BAKERSFIELD CITY SCHOOL DISTRICT
FRANKLIN ELEMENTARY SCHOOL MODERNIZATION
BAKERSFIELD, KERN COUNTY, CALIFORNIA

Job No. 1316
Appl. No. 15-6
File No. 03-122910

ADDENDUM NO. #02
NOTICE TO CONTRACTORS FIGURING THIS WORK

ELECTRICAL SINGLE LINE DIAGRAM

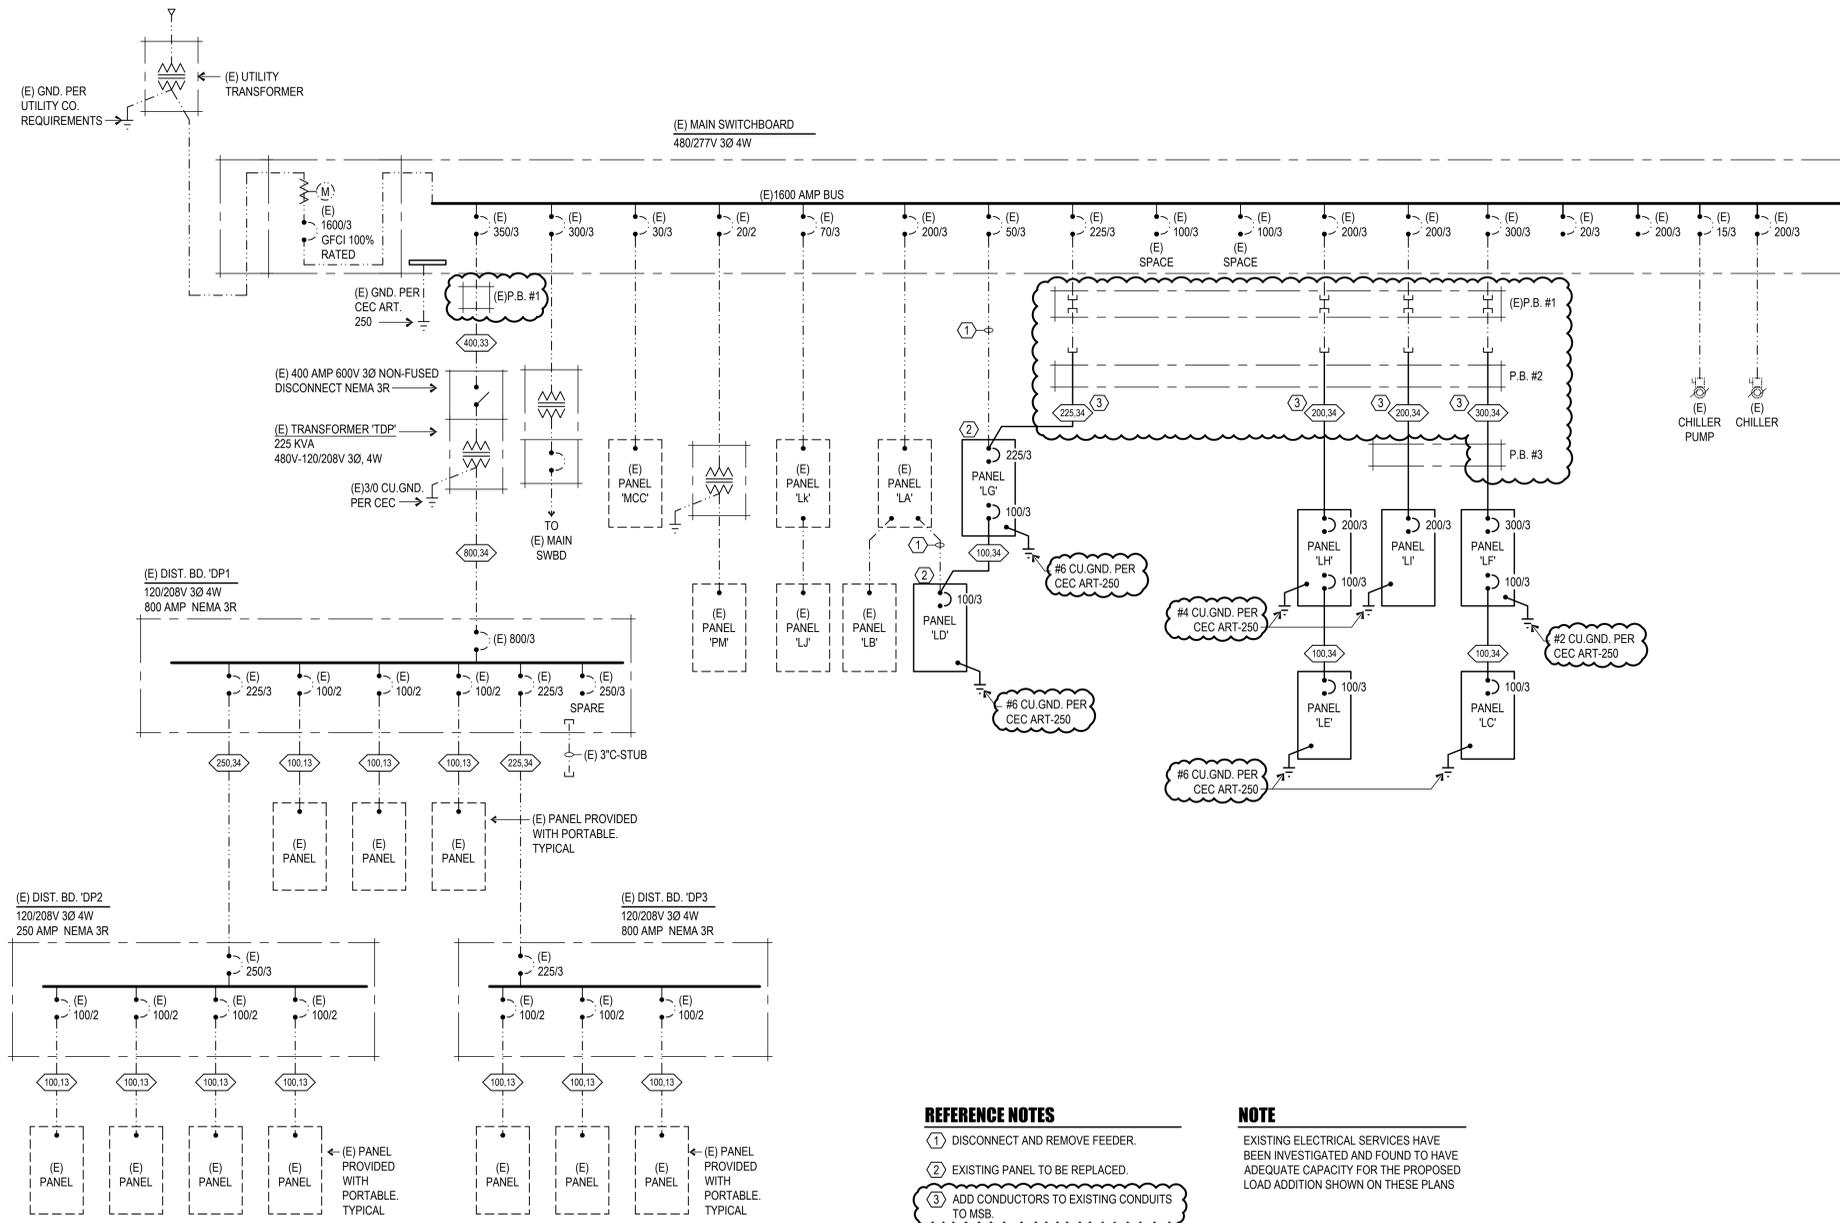
- 2-7) Refer to DSA Approved Drawings, Sheet No. E1.10 ELECTRICAL SINGLE LINE DIAGRAM;
- a. ADD: (E) PB#1 as indicated per attached Drawing AD2E6.
 - b. REVISE: Callouts for pull boxes to be PB#2 and PB#3 in lieu of PB as indicated per attached Drawing AD2E6.

- c. ADD: Grounding for panels as indicated per attached Drawing AD2E6. See also Item 2-6) of this Addendum.
- 2-8) Refer to DSA Approved Drawings, Sheet Nos. E2.10 BLDGS C,D,E LIGHTING FLOOR PLANS AND NOTES and E2.20 BLDGS F,G,H & I LIGHTING FLOOR PLANS, DETAILS AND NOTES;

1 DELETE ATTIC HEAT DETECTORS
ADD ACCESS PANELS

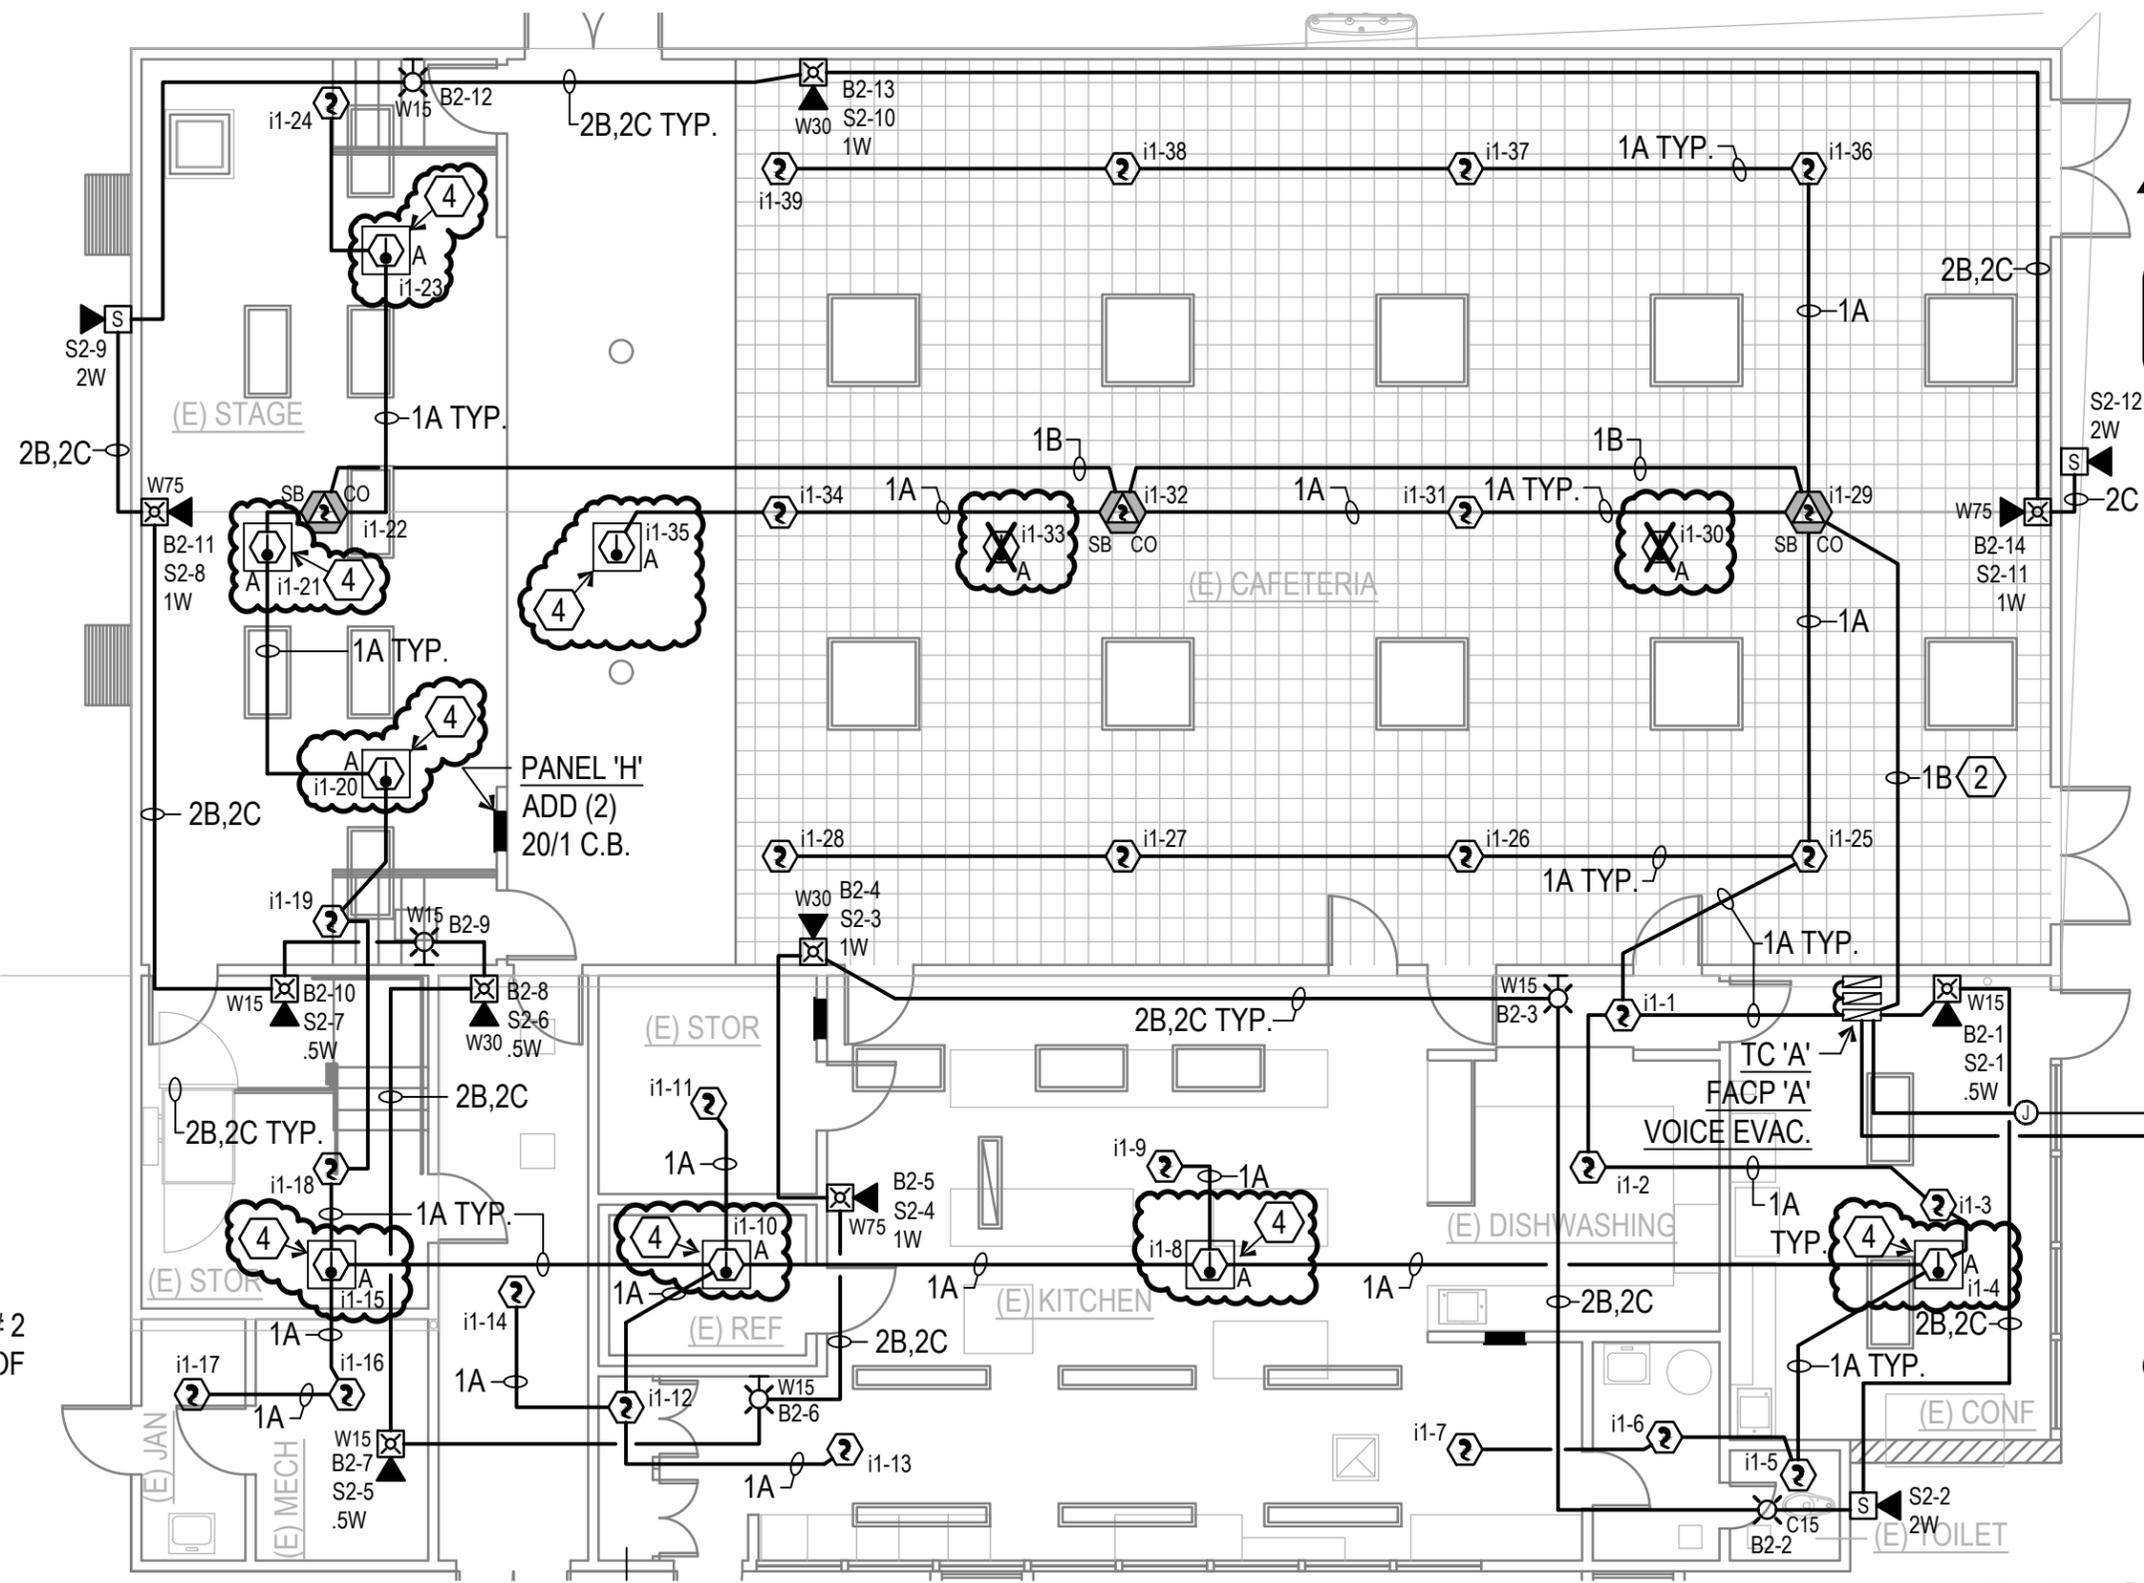
- b. ADD: All fire alarm wiring in areas that the conduit cannot be concealed shall be installed in #2300 wiremold.
 - c. DELETE: At Building A, Two (2) attic heat detectors in room (E) Cafeteria. See attached Drawing AD2E7 and AD2E8 for revised fire alarm in Building A.

- d. ADD: At Building A access panels for heat detectors. See attached Drawing AD2E7.
- 2-12) Refer to DSA Approved Drawings, Sheet No. E4.20 BLDGS F,G,H & I FIRE ALARM FLOOR PLANS;

- 1 HEAT DETECTOR AT APEX OF RAISED ROOF.
- 2 1B TO FATC IN THIS BUILDING THEN CONTINUE TO FACP PER SINGLE LINE DIAGRAM.
- 3 RELAY AT AC UNIT 'HP-2', FOR AUTOMATIC SHUT OFF PER CMC 608.
- 4 PATCH AND MATCH (E) CEILING FINISH AS REQUIRED FOR ACCESS PANEL. SEE DETAIL 20 / A10.2

1 DELETE ATTIC HEAT DETECTORS AND REVISE FACP AND VOICE EVAC TO EXISTING

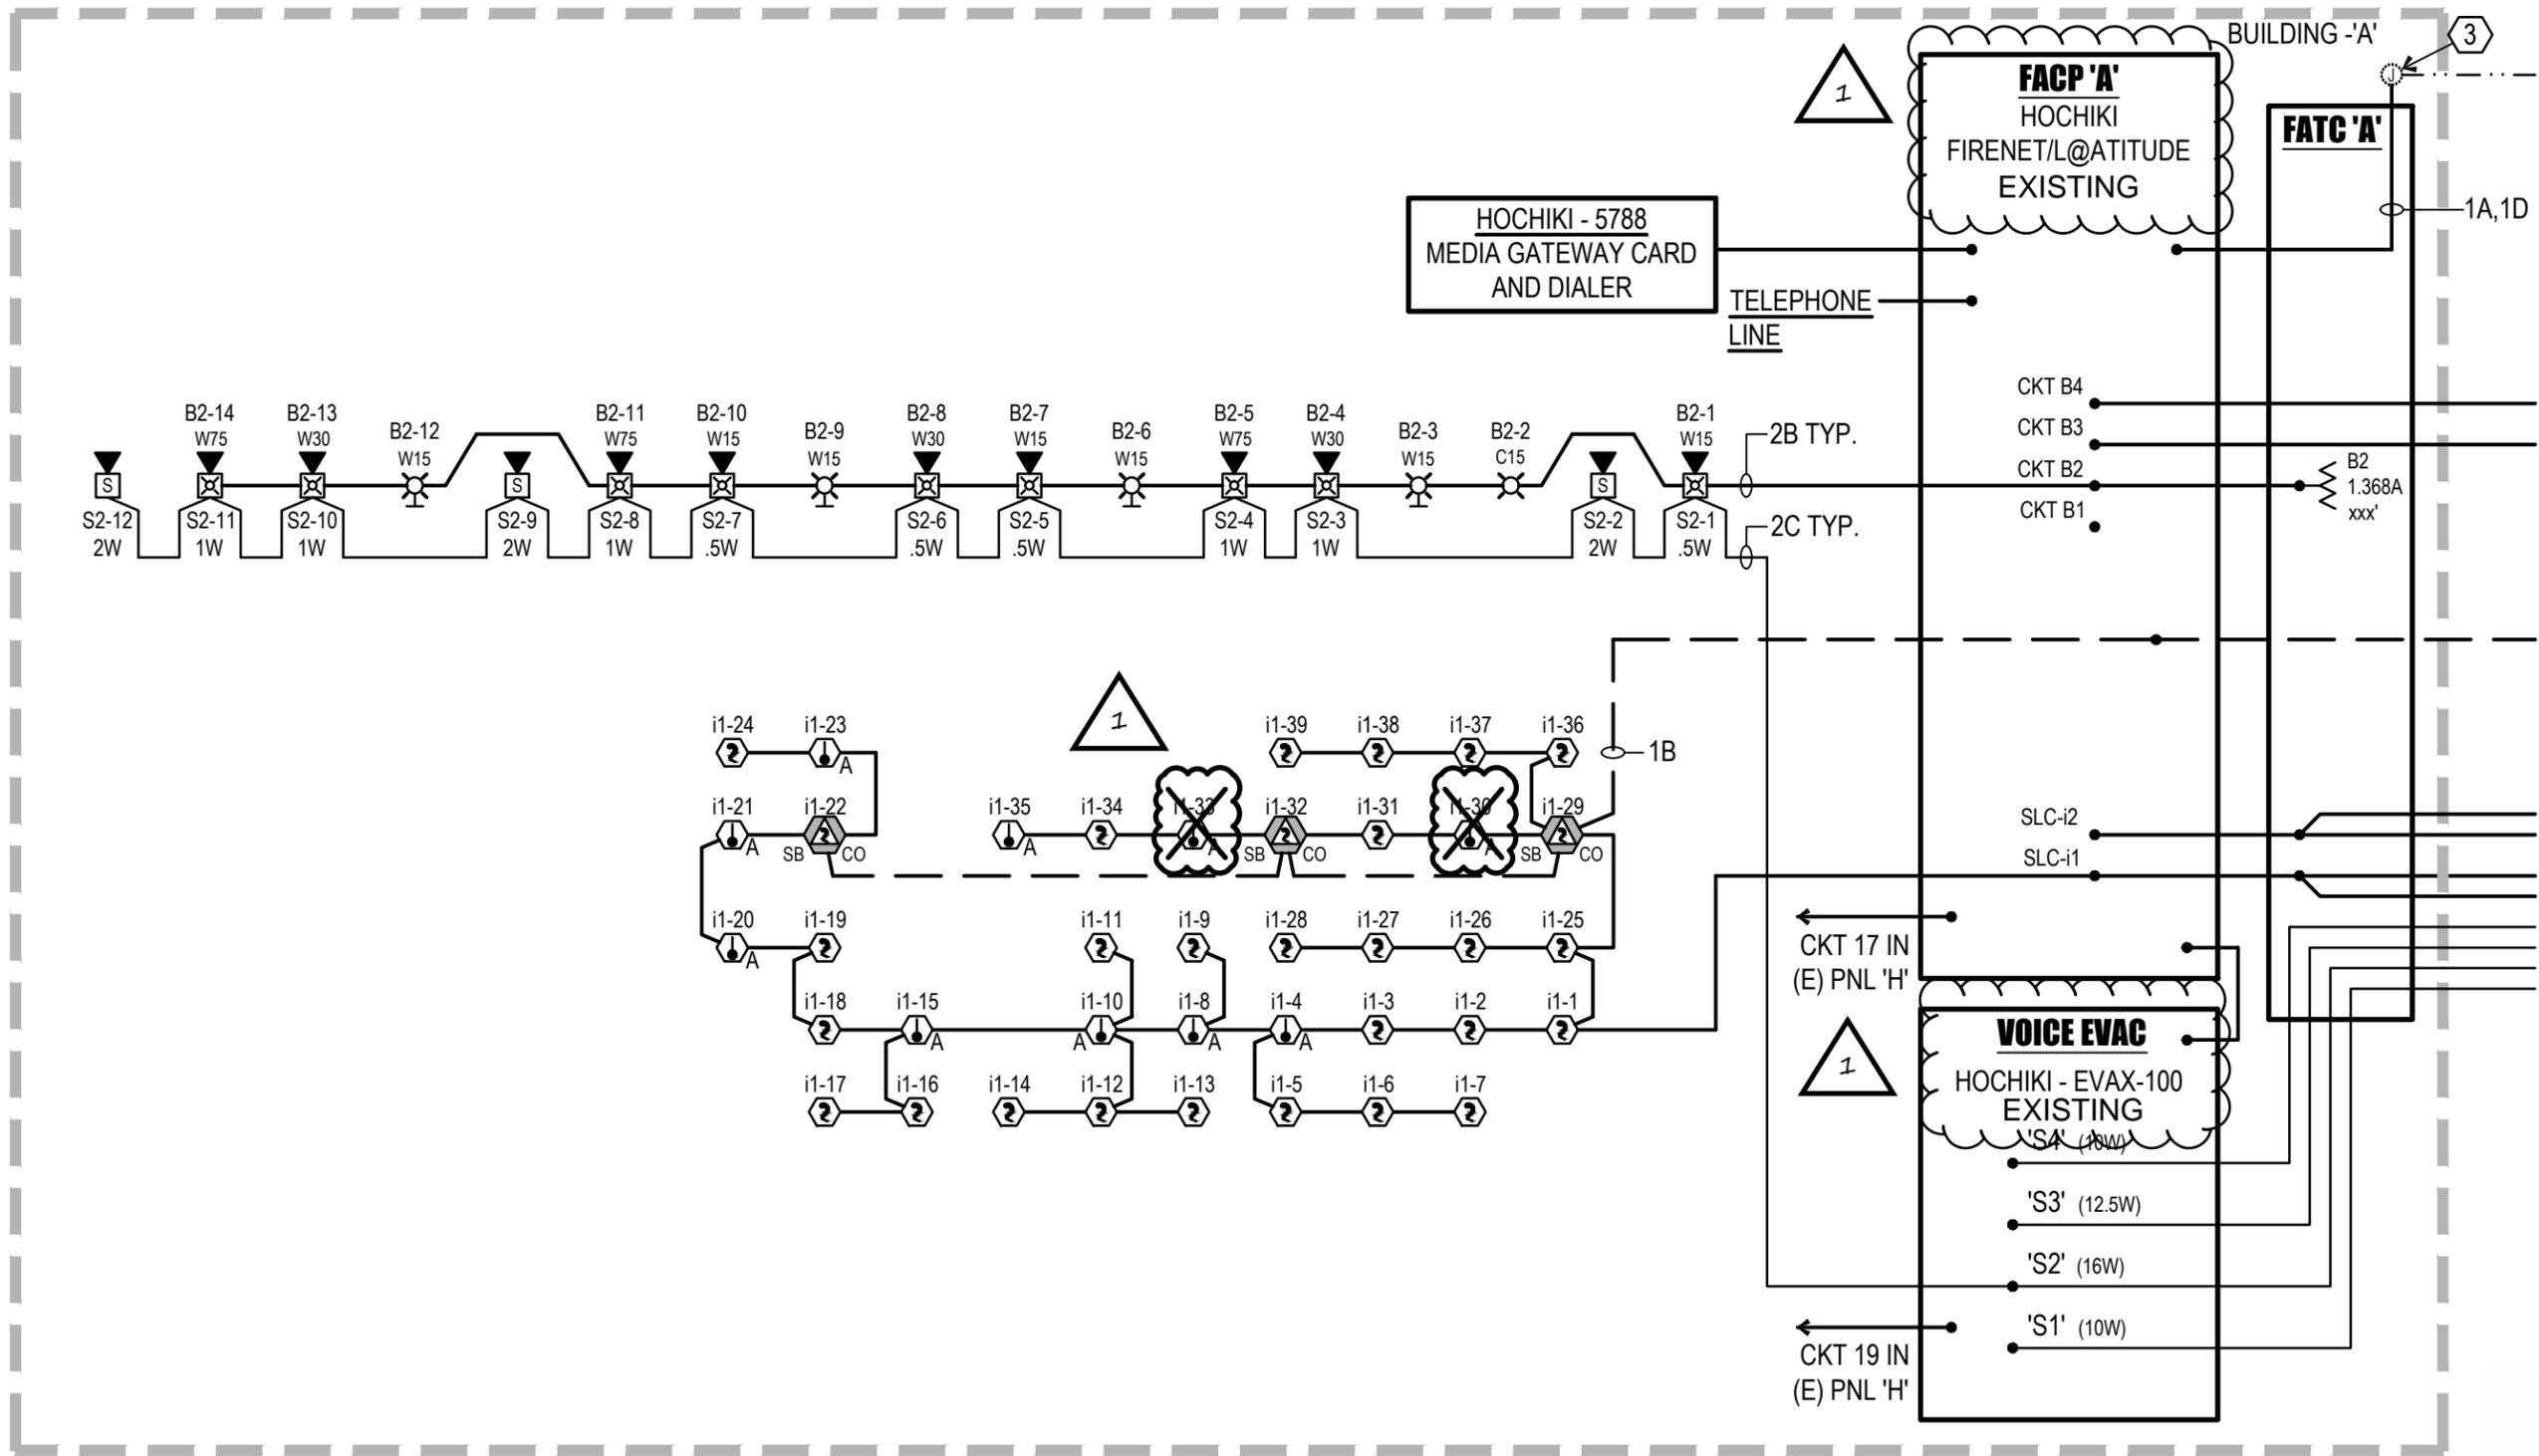
- a. REVISE: The fire alarm control panel and the voice evacuation panel indicated on these plans are existing. See attached Drawing AD2-E8.
